U.S. Department of the Interior
BUREAU OF LAND MANAGEMENT

Well Name: WBR FEDERAL	Well Location: T22S / R32E / SEC 13 / SWSW /	County or Parish/State: LEA / NM
Well Number: 02	Type of Well: OIL WELL	Allottee or Tribe Name:
Lease Number: NMNM58940	Unit or CA Name:	Unit or CA Number:
US Well Number: 3002532999	Well Status: Inactive	Operator: OXY USA INCORPORATED

Notice of Intent

Type of Action: Plug and Abandonment

OXY USA Inc. Proposed
WBR Federal #2
API No. 30-025-32999

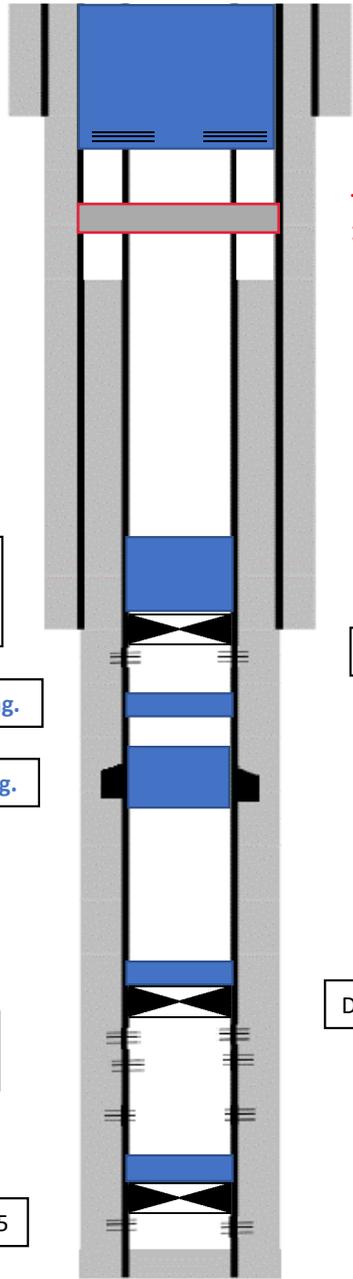
Bell/int shoe/delaware lime/ basal anhydrite-
Set CIBP 4881'. Spot 55 sx cmt 4881' to 4440'.
WOC and Tag. **Leak test 500psi, 30mins**

**Top of salt plug: Perf and sqz 30sx Class C from
1446' to 1332'. Tag and verify**
